ADDENDUM AD 02

Project:	Provincial Fire Life Safety – Lynn Lake, Gillam, and Thompson Sites	
Commission Number:	21569.44, 21569.49, 21569.50	SMS Project No.: 25-001-16
Date:	November 13, 2025	
Pages:	2 + 2 attachment/s

Project:	PFLS Gillam Hospital	Addendum Number:	01
Owner:	PMH	Project Number:	2025-0285
Issued by:	SMS	Date Issued:	November 7, 2025
Distribution:	SMS – Ethan McTavish (emctavish@smseng.com) SMS – Martyn Borovystkyy (mborovystkyy@smseng.com)

Project:	PFLS Lynn Lake, Gillam, and Thompson Sites	Addendum Number:	01
Owner:	PMH	Project Number:	2025-0433
Issued by:	SMS	Date Issued:	November 7, 2025
Distribution:	SMS – Ethan McTavish (emctavish@smseng.com) SMS – Martyn Borovystkyy (mborovystkyy@smseng.com)

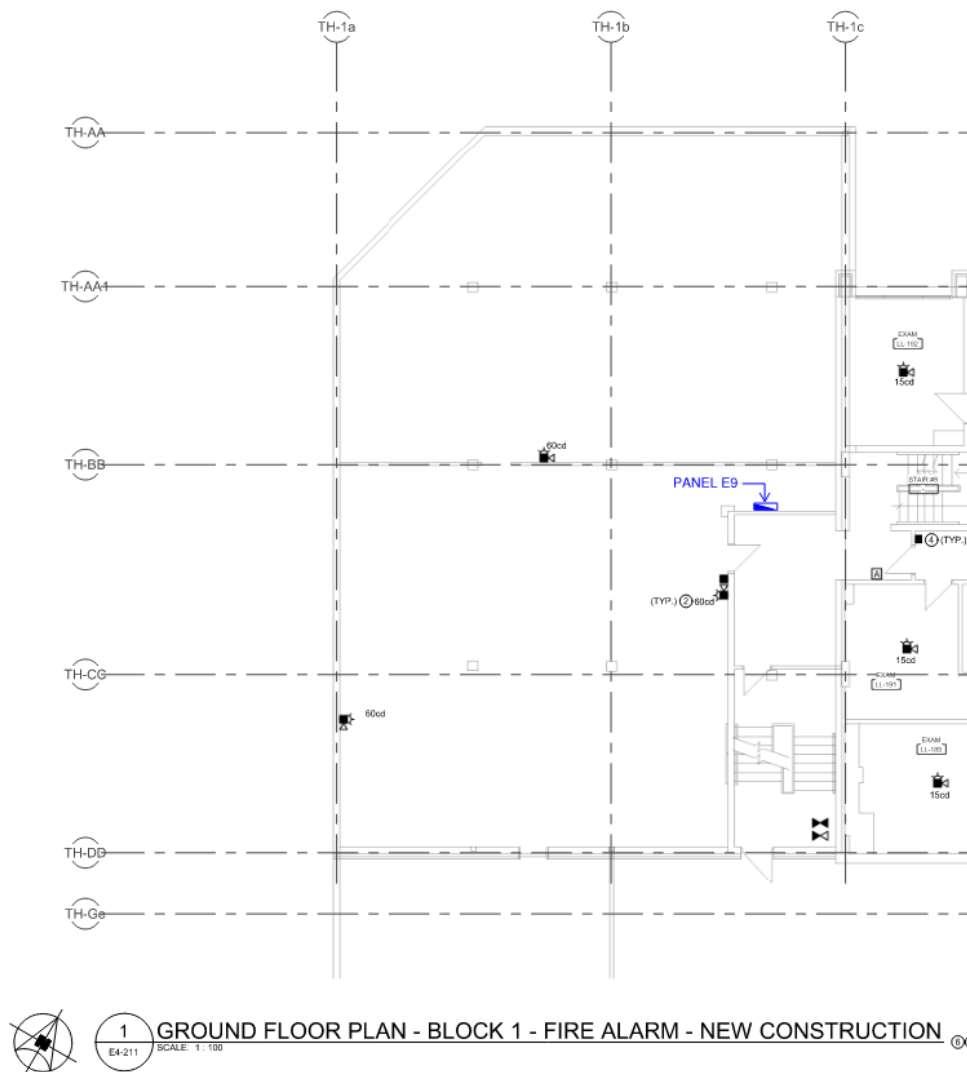
- .11 Refer to drawing E4-221 – First Floor Plan – Block 1 – Fire Alarm – New Construction
 - .1 Provide interconnection between new fire alarm control panel for Thompson Hospital building and existing fire alarm control panel of adjoining NRHA Administrative building to the north. Refer to below sketch for location of NRHA administrative building fire alarm control panel on ground/basement level.

Panels shall be interconnected so that an alarm on one fire alarm system raises a trouble/supervisory condition on the other fire alarm system.

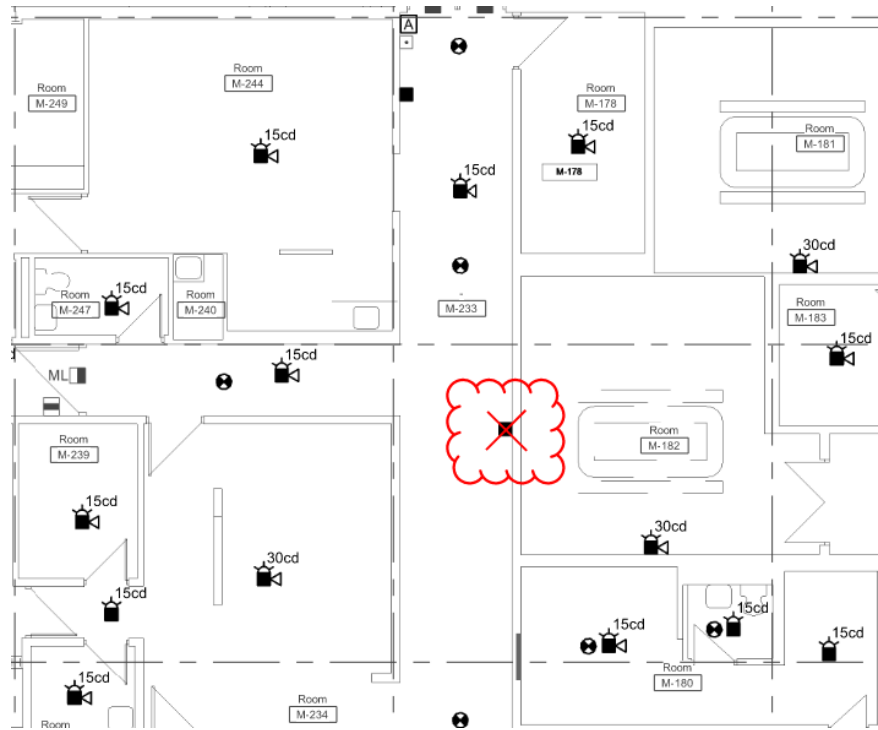
- .2 Provide standalone carbon monoxide detector and alarm within Ambulance Bay 144, refer to specification revisions for standalone CO detector requirements. CO detector shall be monitored by the fire alarm system.
- .1 Provide new 120V emergency power circuit from existing Panel E9, see below sketch for panel location on ground level. Provide new 15A-1P breaker to match existing.
